**From:** [REDACTED]  
**To:** [REDACTED]  
**CC:** [REDACTED]  
**Sent:** 2/23/2021 6:39:50 PM  
**Subject:** RE: O8W-PM [REDACTED] - Bucks Creek 1101 Phase 1,2&3 - Pre-Engineering Meeting

# Bucks Creek 1101- PM# [REDACTED] Overview Map

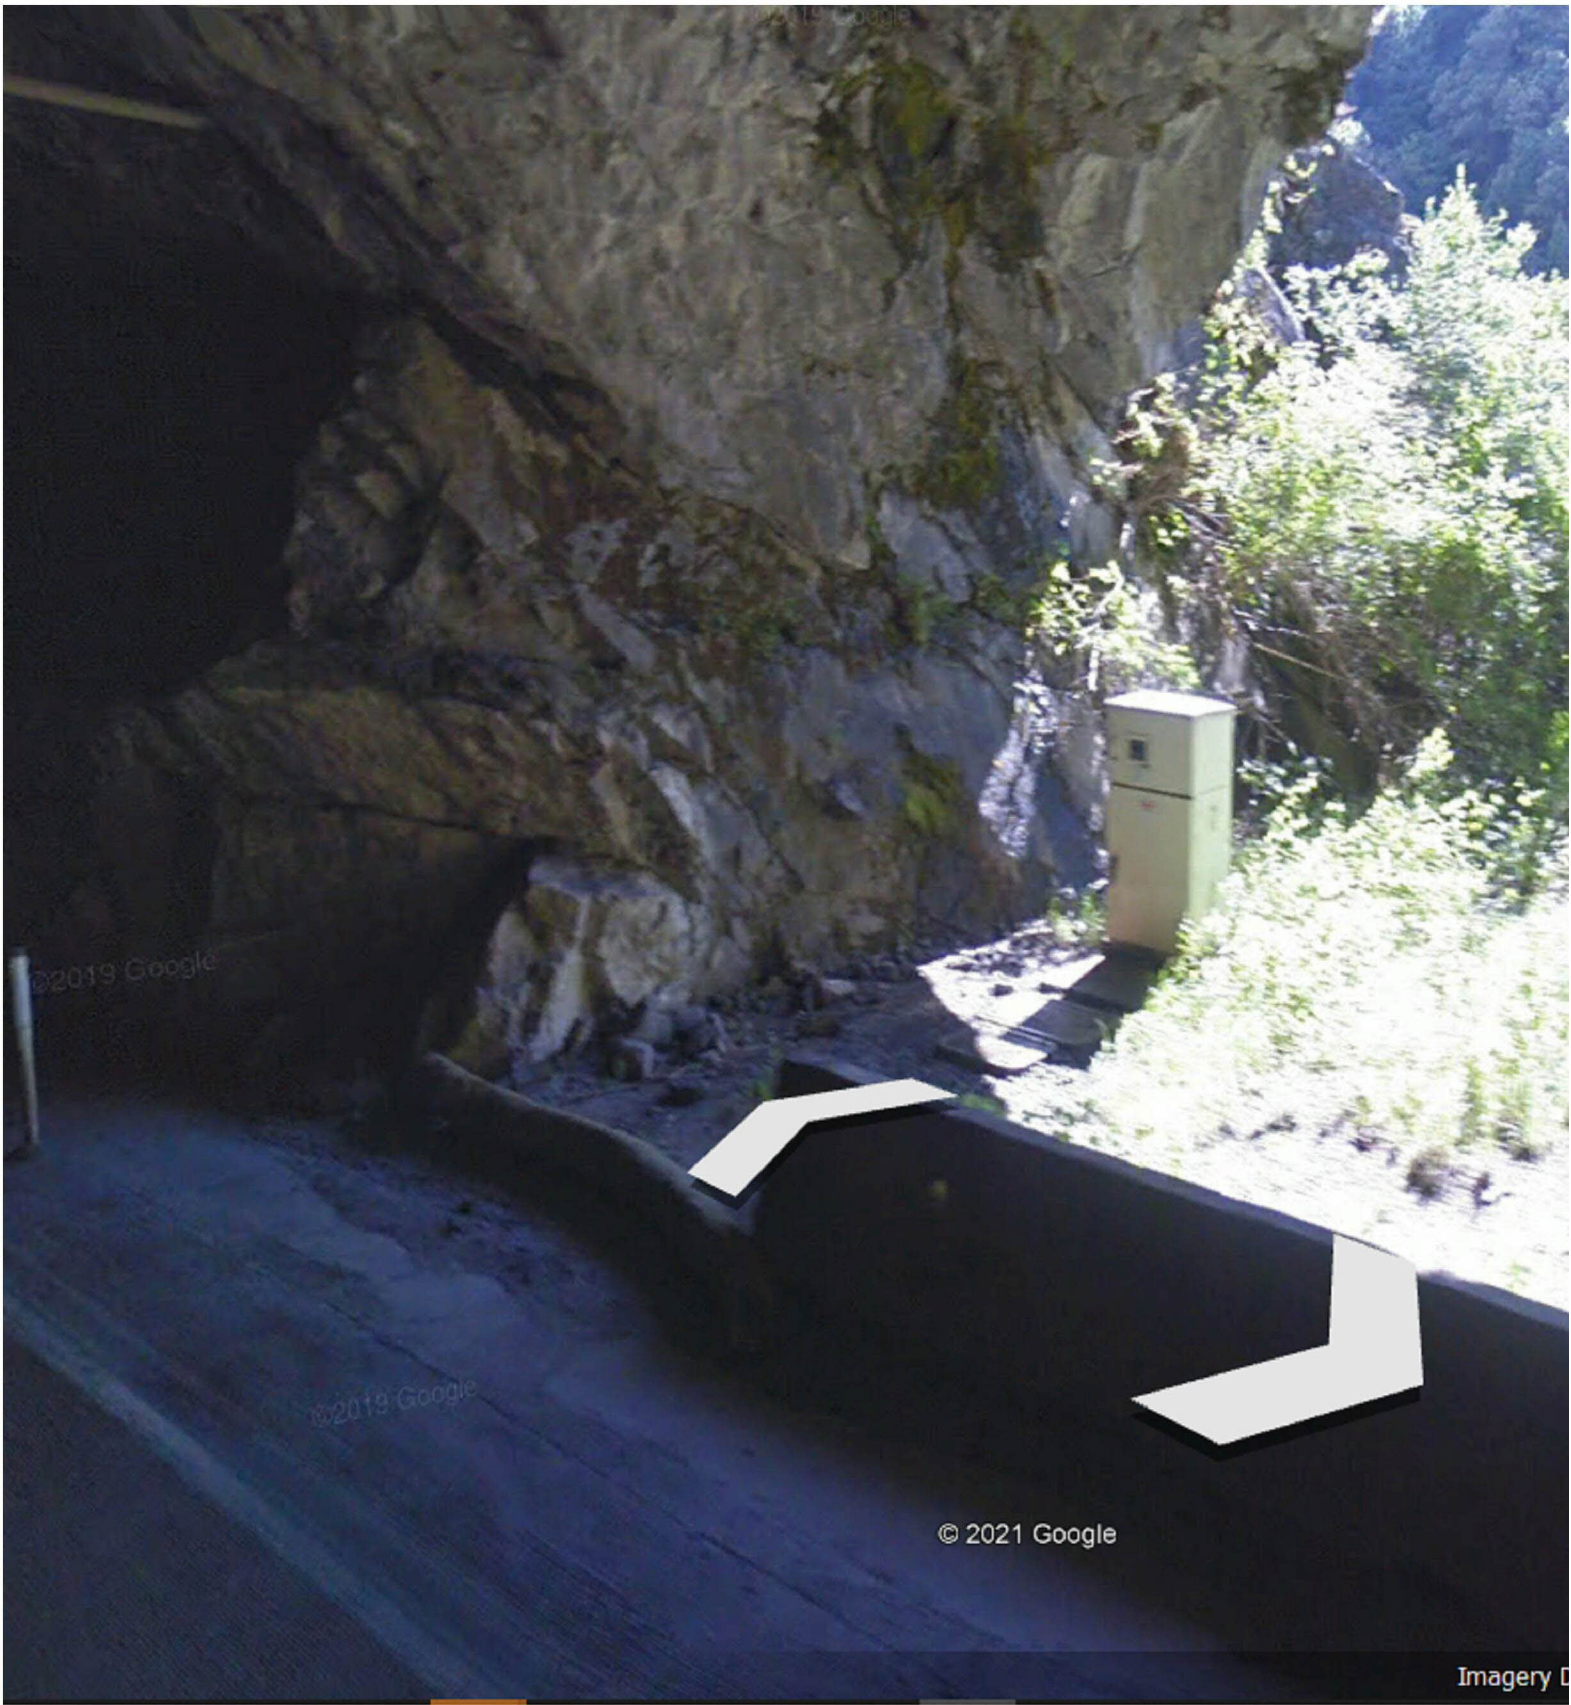
Attached are the 'base-map' limits in a kmz. file. As you will see, we need our base-map to go about ~100' into the tunnel at the south end (see pedestal in picture below....please begin about ~50 beyond this point which is about ~100' beyond the Cresta Dam).

We want to end the base-map at the sign location below which is roughly at [REDACTED]

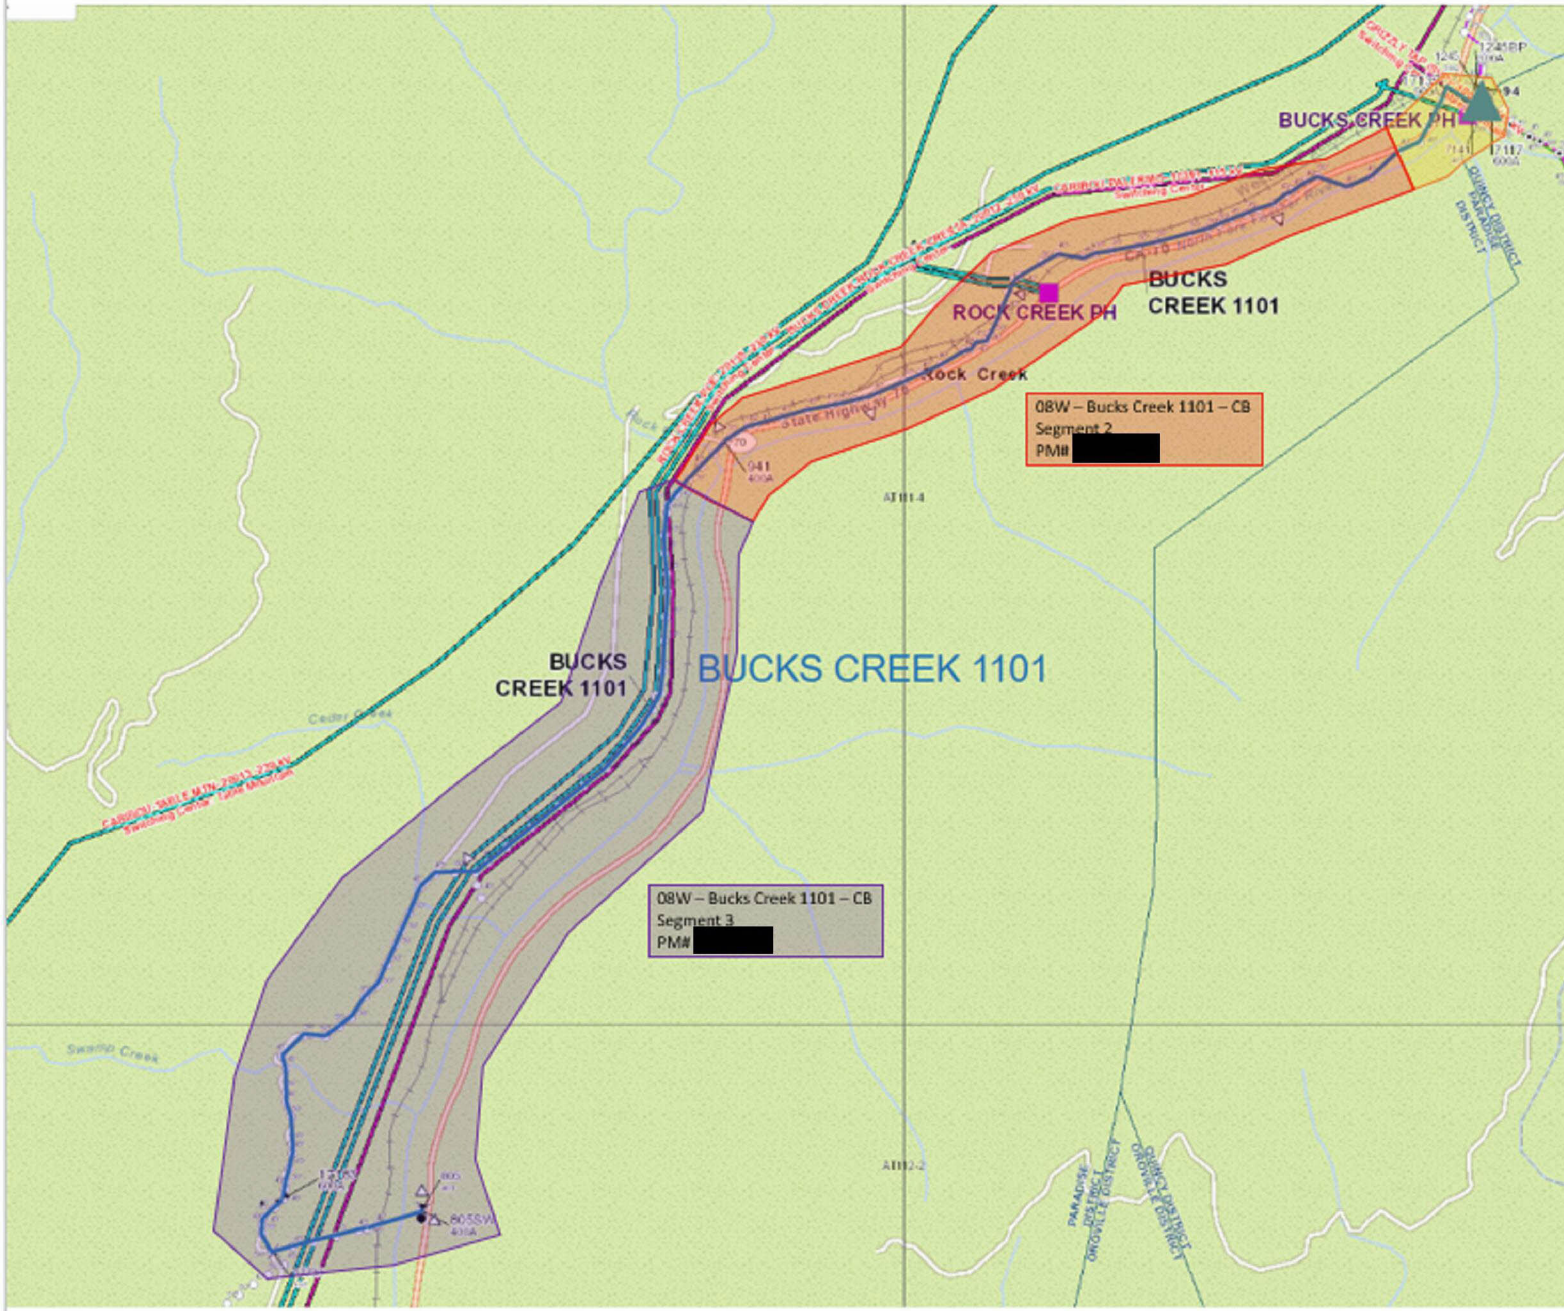
For Bucks Creek there is quite a bit of work surrounding Hwy 70 and we will need a Land Department Base Maps prepared for all 3 Orders. This will delay the EOD dates until these can be developed and provided to the Vendor... We will also need answers to the questions outlined by [REDACTED] below...
